Generic Evaluation of Small Break Loss-of-Coolant Accident Behavior in Babcock & Wilcox Designed 177-FA Operating Plants

Office of
Nuclear Reactor Regulation

U.S. Nuclear Regulatory
Commission

**Bulletins and Orders Task Force
Office of Nuclear Reactor Regulation
U.S. Nuclear Regulatory Commission
Washington, D.C. 20555**

FIGURE 4-2

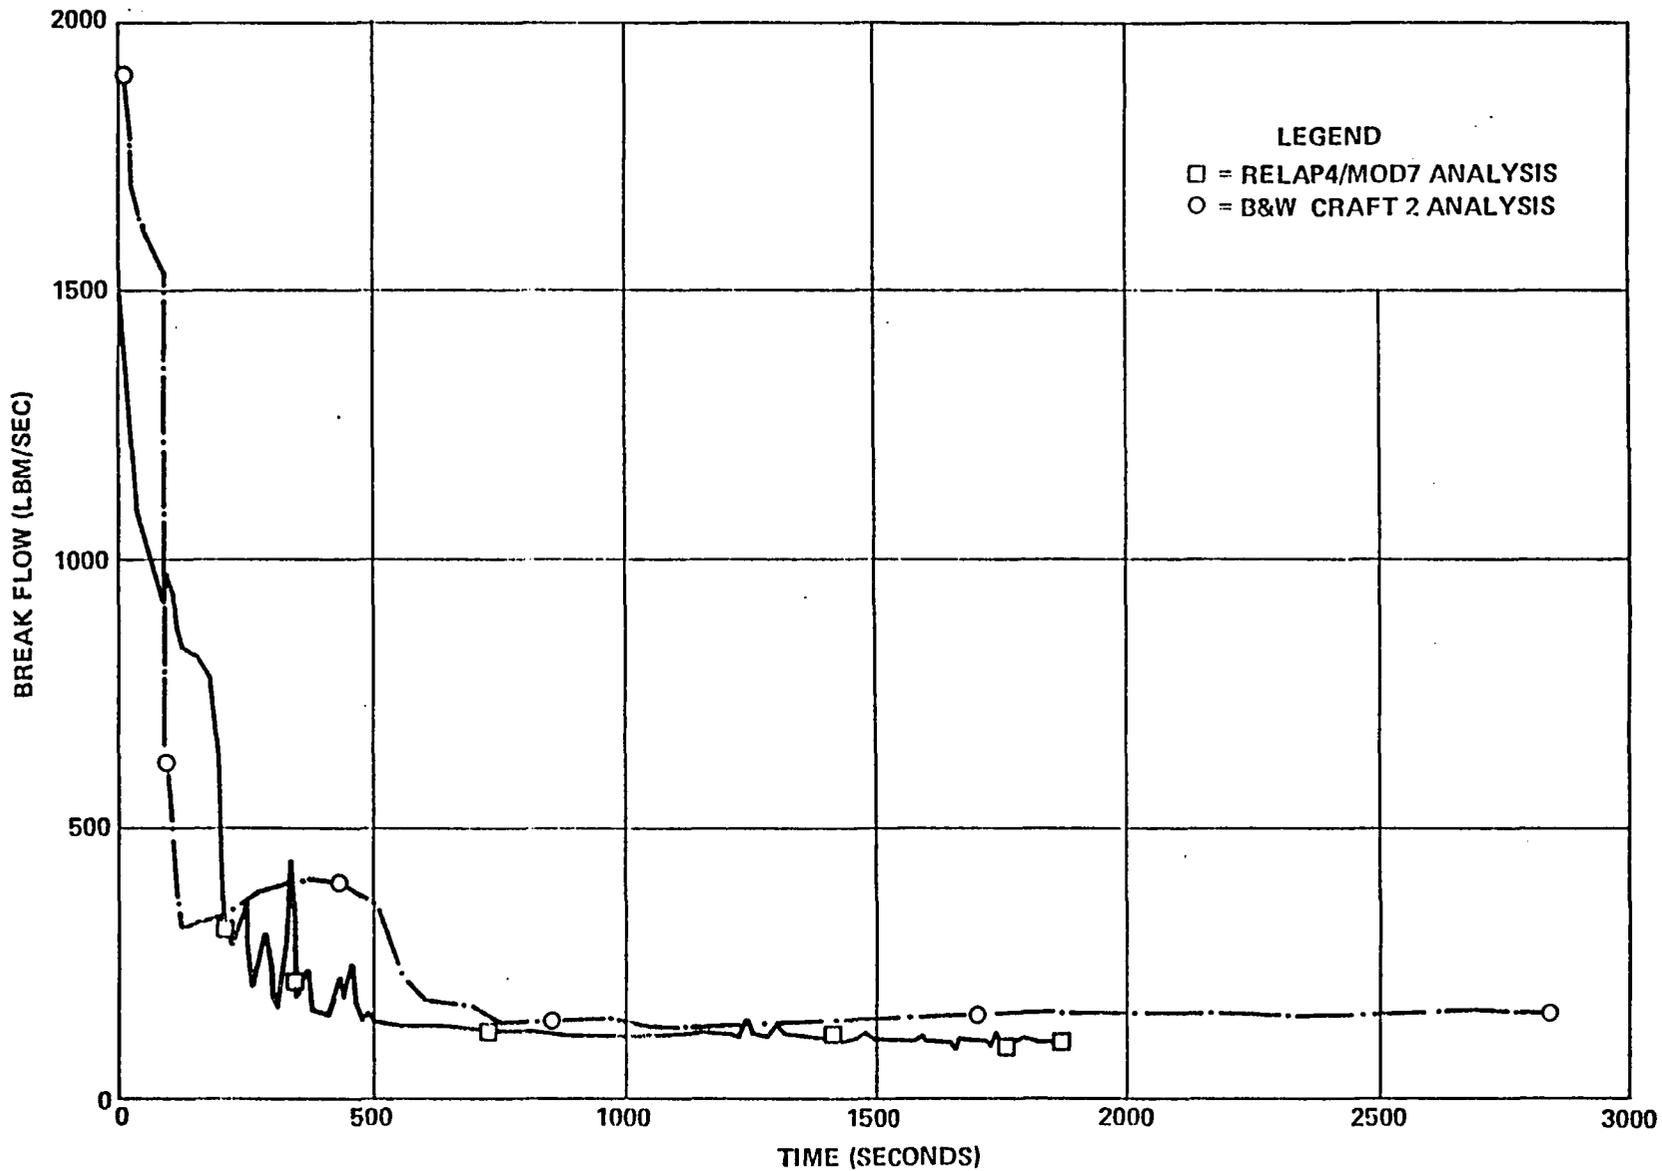
As expected, the B&W analysis shows a more rapid depressurization early in the transient (Figure 4-2), a result of the critical flow model used, as shown in Figure 4-3. In the staff analysis depressurization occurs until about 650 seconds when the AFW has refilled the steam generator secondaries to the control level of 20.2 feet. At approximately 950 seconds, the primary and secondary side equilibrate and the heat transfer switches from a secondary to primary mode for the remainder of the transient. This can be seen in Figure 4-4.

FIGURE 4-6

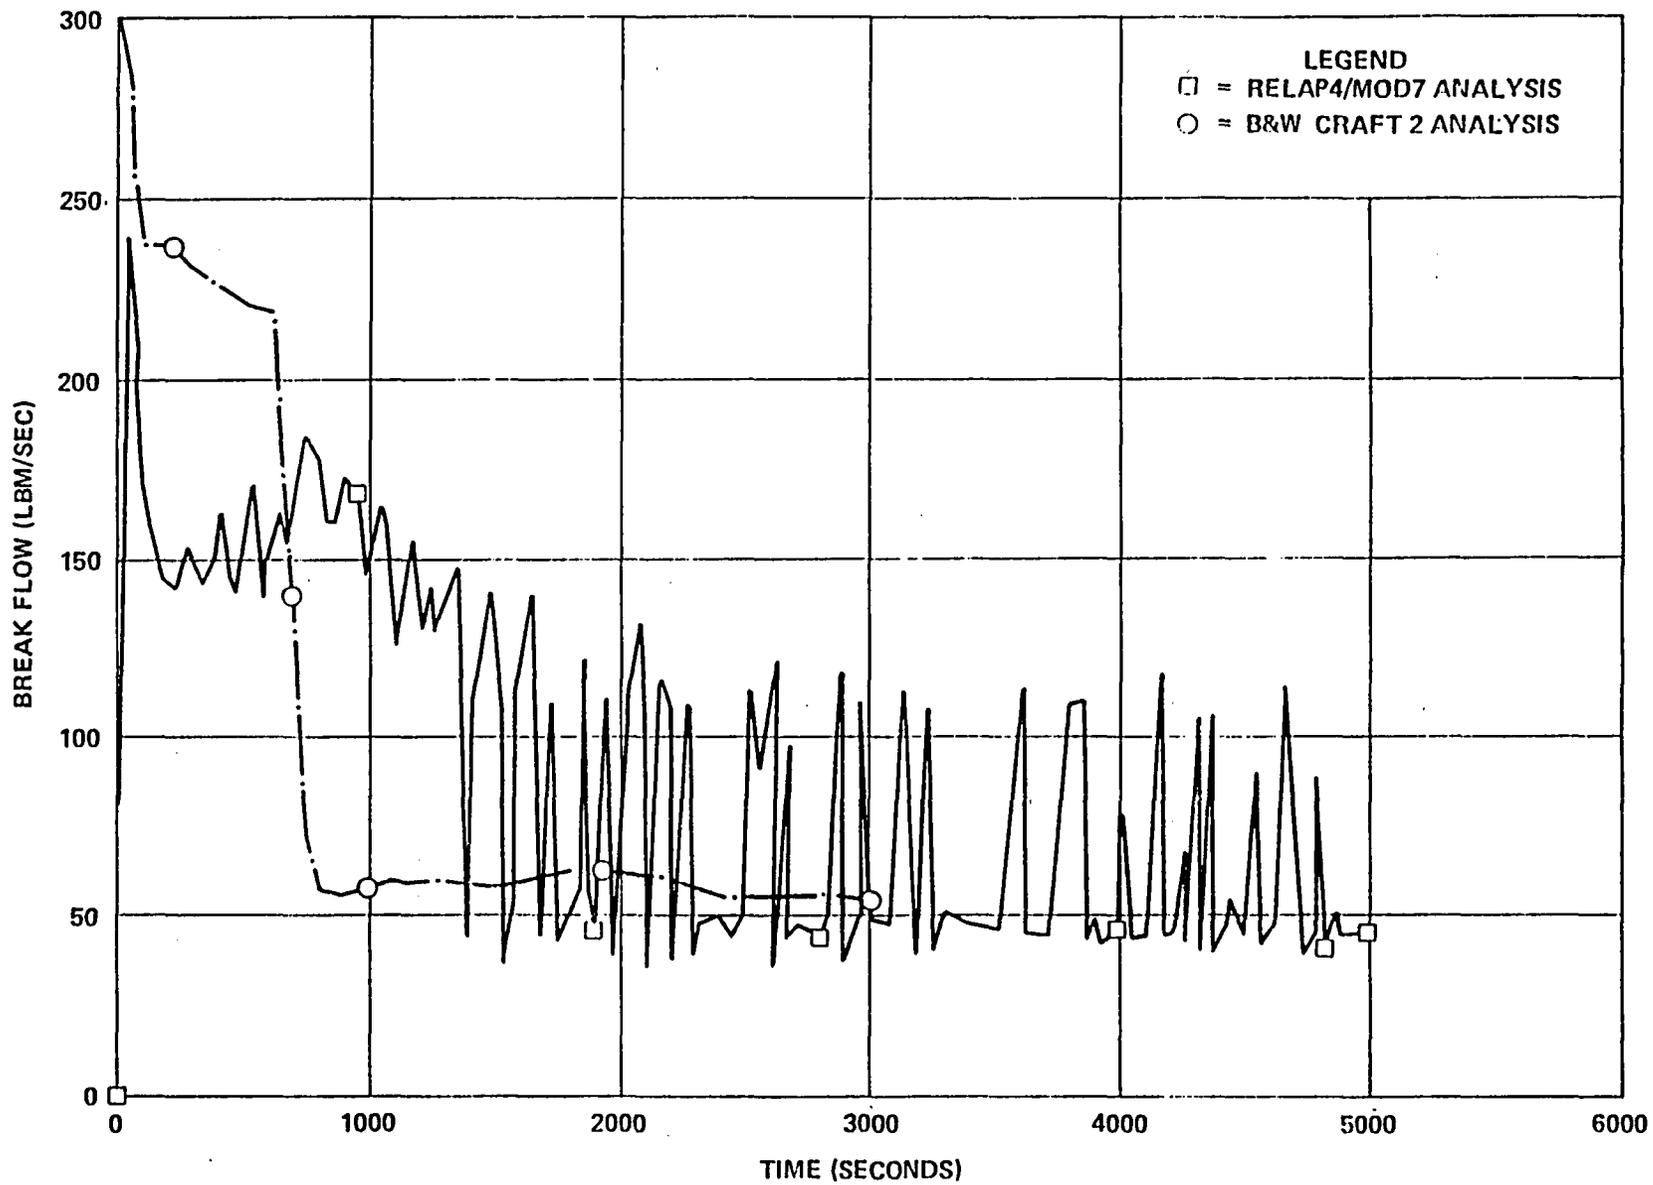
The analysis of the 0.01 ft² break with AFW is shown in Figures 4-6 and 4-8. The reactor coolant system pressure response is shown in Figure 4-6. The break flow is shown in Figure 4-7, and the secondary side pressure response is shown in Figure 4-8.

The influence of the critical flow model and the OTSG model is seen in Figures 4-7 and 4-8. The interesting comparison is found in the reactor coolant system pressure response, Figure 4-6. In the B&W analysis, the loss of natural circulation is quite pronounced, resulting in the repressurization to 1750 psia at about 1500 seconds. In the staff analysis, natural circulation is lost for a much shorter period, and the pressure tends to hang up while the steam generator pressure is near the safety valve setpoint.

FIGURE 4-12 REACTOR COOLANT SYSTEM ARRANGEMENT
 FOR THREE MILE ISLAND UNIT 2
 (SELECTED ELEVATIONS)

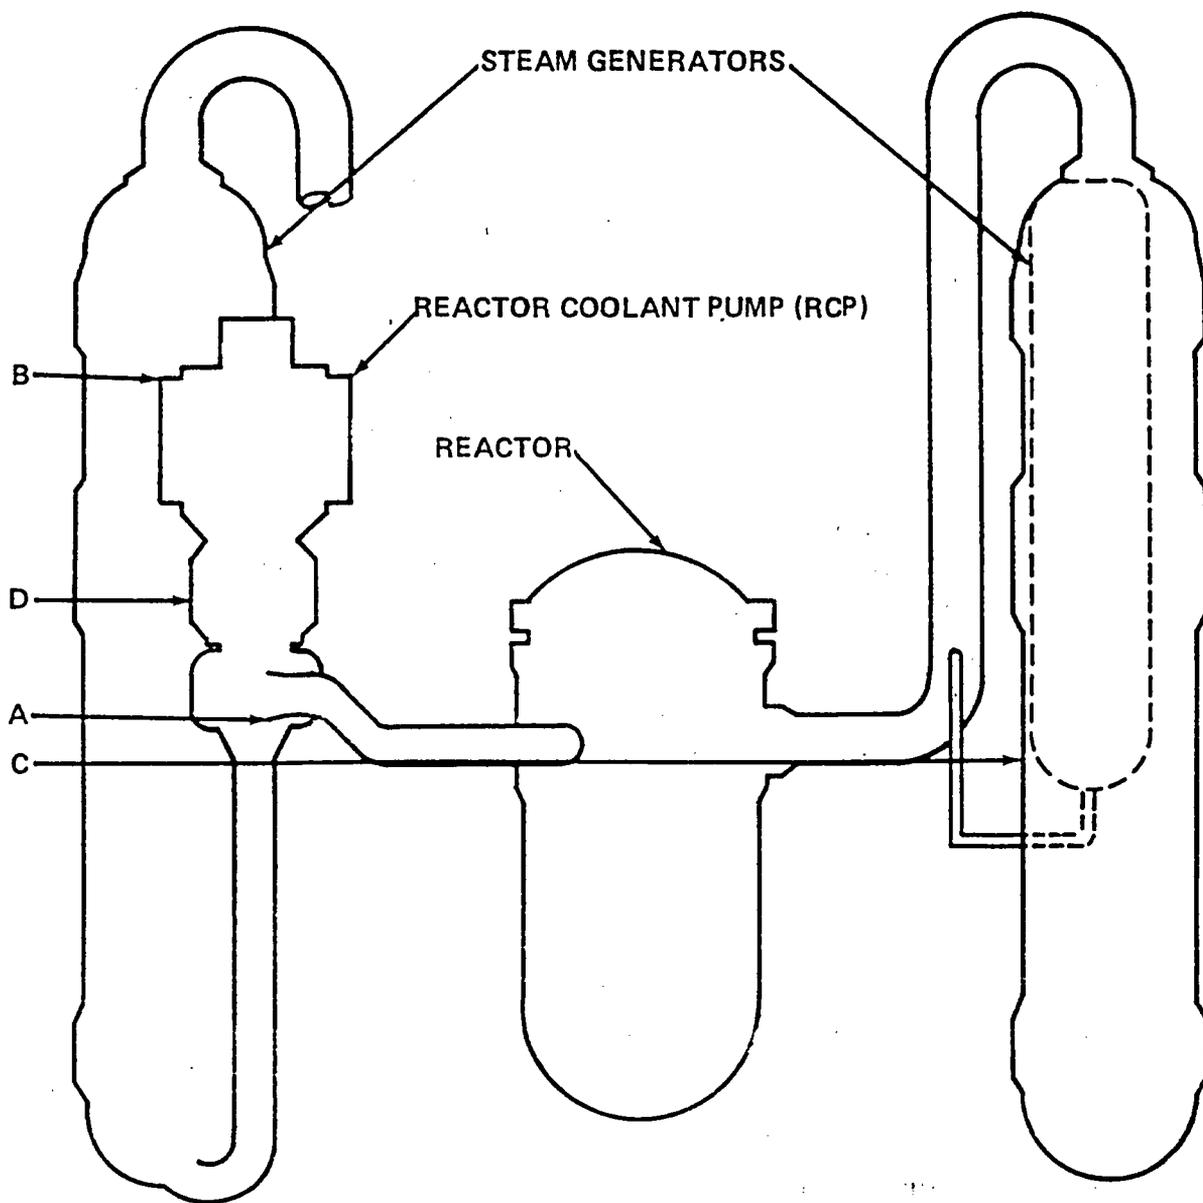
Based on examination of the component elevations in the plant, the steam generator secondary level setpoints, and the estimated primary system inventory, it is believed that the inability to achieve natural circulation flow can be qualitatively explained.

When the RCPs were tripped, the steam and liquid phases separated, with the liquid falling to the lower elevations of the primary system. For the TMI-2 plant, this is the bottom of the steam generators, the RCP suction piping, and the bottom of the reactor vessel, as can be seen on Figure 4-12. Also shown on Figure 4-12 is the elevation (elevation C) of the automatic feedwater control level setpoint, which was set to control level at 50 percent of the operating range when the RCPs were tripped. Since the TMI-2 accident, B&W has recommended that this level setpoint be increased to 95 percent of the operating range whenever the RCPs are tripped.

(elevation A in Figure 4-12). Feedwater enters the steam generators through a sparger at elevation B (see Figure 4-12), and would normally produce a condensing surface well above that needed to force the water in the RCP suction piping up through the RCP and into the discharge piping; however, feedwater will only be supplied if it is replenishing liquid lost through boiling. Without the initial flow of liquid out of the steam generators and into the reactor vessel, the stagnant primary coolant in the lower portion of the steam generator tubes will eventually reach equilibrium with the secondary water which will be held at the 50 percent level on the operating range (elevation C in Figure 4-12). When the heat transfer stopped, so did the boiling of the secondary water. This, in turn, stopped the feedwater demand, and the condensing surface due to sparger spray above the RCP discharge nozzle was lost. The only condensing surface left was the secondary water level, and it was below the elevation necessary to allow water to flow through the RCP and into the reactor vessel. Thus, liquid could not flow from the steam generators to the vessel, and the steam produced in the core could not condense in the steam generators.

Subsequent to the accident at TMI-2, B&W has included in its operating guidelines for small breaks the requirement for the operators at the lowered loop plants to manually raise the steam generator secondary water level to 95 percent on the operating range in the event that the RCPs are tripped. This is shown as elevation D in Figure 4.12.
